Docket No. 50-423
B14846

Millstone Unit No. 3

Proposed Revision to Technical Specifications
Generic Letter 93-05 and Various Administrative Changes
Marked-Up Pages

June 1994

FIGURE 4.7-1
 SAMPLE PLAN 2) FOR SNUBBER FUNCTIONAL TEST

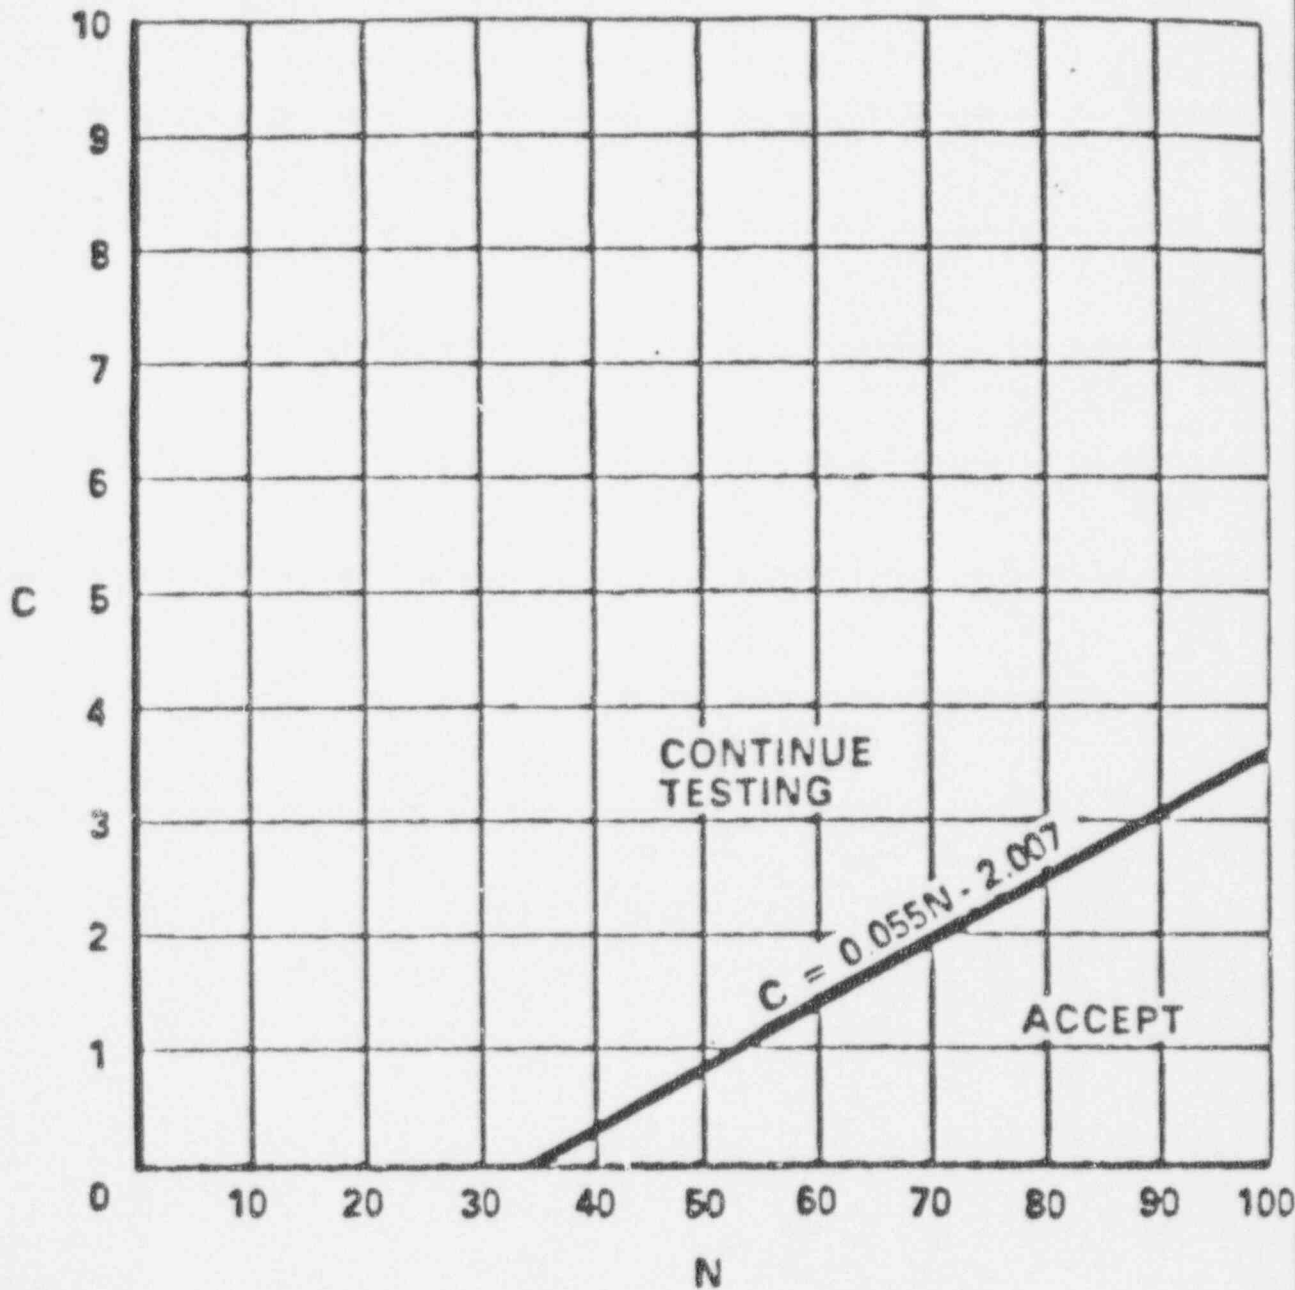
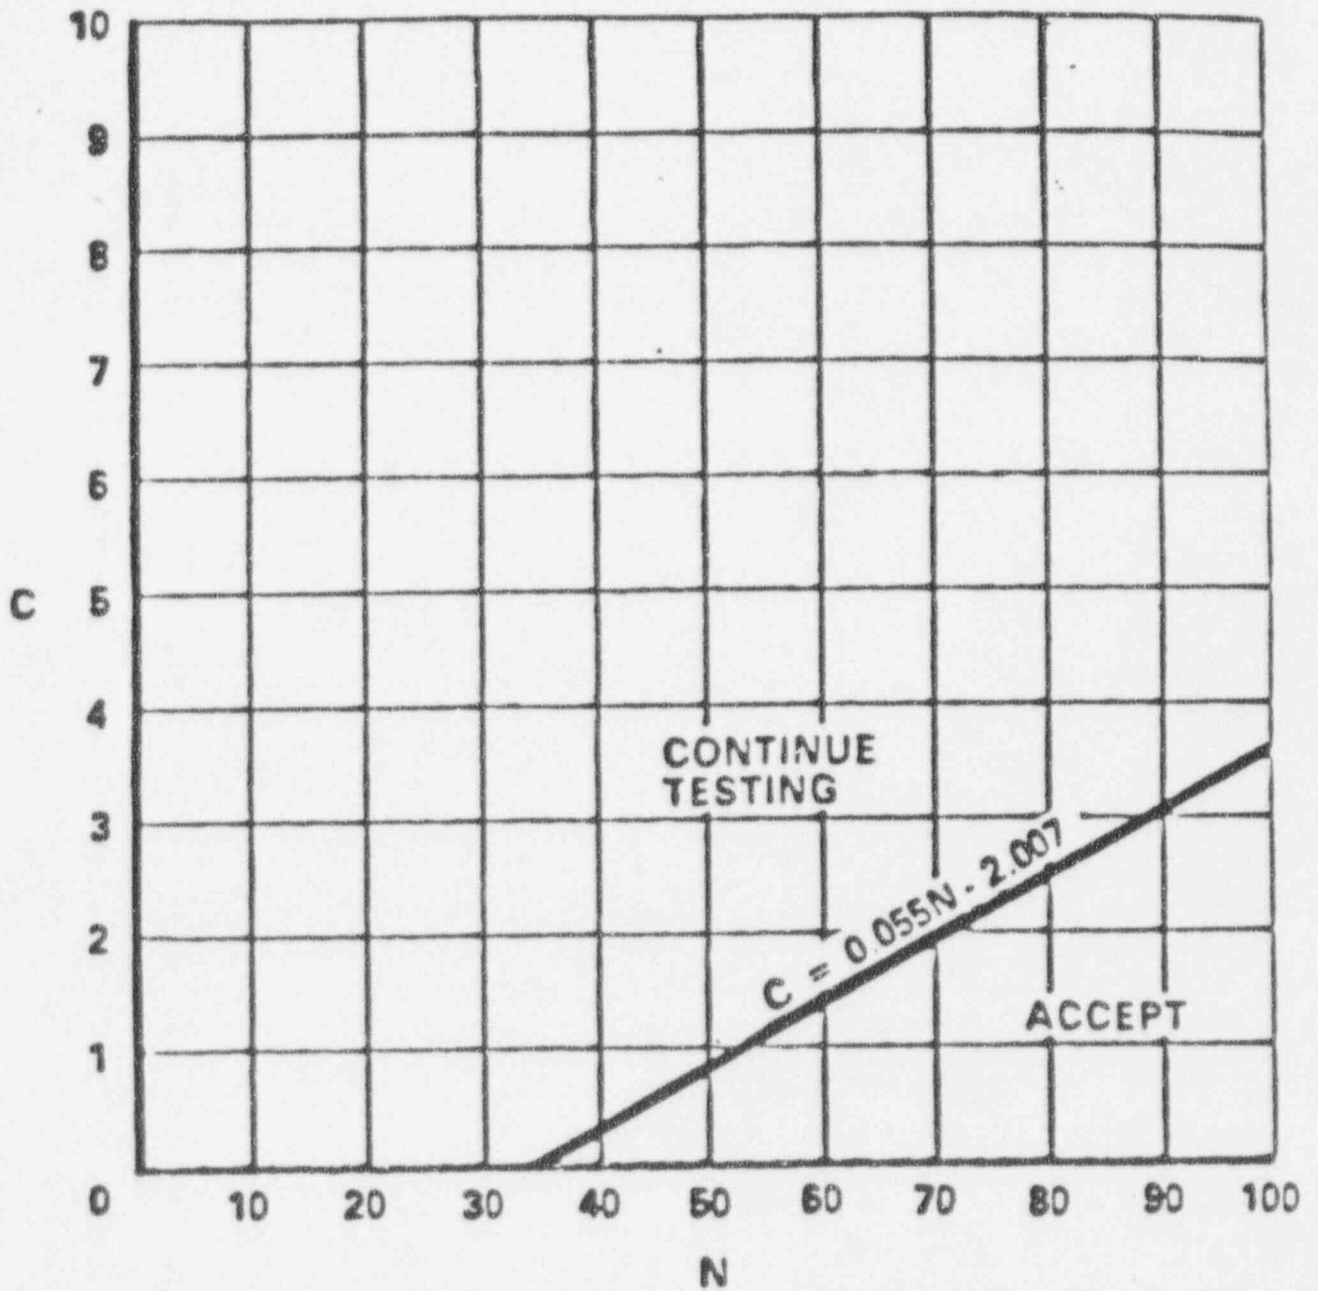
4.7.1.2.1.a and b	Auxiliary Feedwater System	3/4 7-4 and 5	GL 93-05
4.7.10.e	Snubbers	3/4 7-23	Administrative
Table 4.7-2	Snubber Visual Inspection	3/4 7-26a and 26b	Administrative
Figure 4.7-1	Sample Plan 2) for Snubber Functional Test	3/4 7-27	Administrative
3/4.7.11	Sealed Source Contamination	3/4 7-28 and 29	Administrative
N/A		3/4 7-30 through 43	Administrative
3/4.7.14	Area Temperature Monitoring	3/4 7-44	Administrative
Table 3.7-6	Area Temperature Monitoring	3/4 7-45 through 47	Administrative
